Advisory Committee on Reactor Safeguards

C-10 Presentation; Technical

Victor E. Saouma

Sept. 4, 2024

Supplement to License Amendment Request 16-01 Request to Extend Containment Leakage Test Frequency

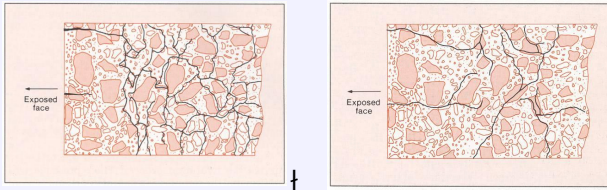
C-10 Comments

- ASR causes cracks and microcracks, which **not always visible**. These may coalesce and **create a continuous pathway** for gas release.
- There is three-directional reinforcement **only around the base**, while “skin” reinforcement is applied **only on the intrados and extrados**.

The Myth of No Shear Strength Loss from AAR

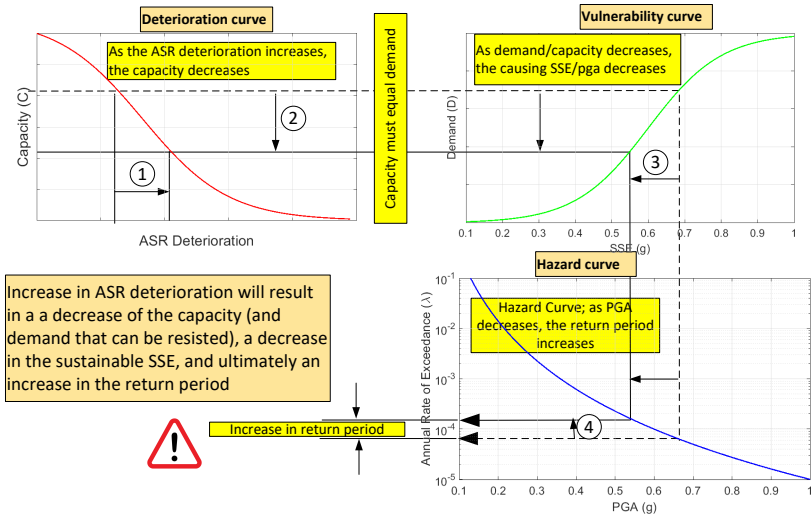
- The persistent myth that there is no shear reduction due to AAR in the CEB has been **conclusively disproven** by findings from two separate NRC-funded research programs.
- AAR will lead to significant shear reduction, critically **undermining resistance to earthquake excitation**.
- The **Demand** is grossly underestimated
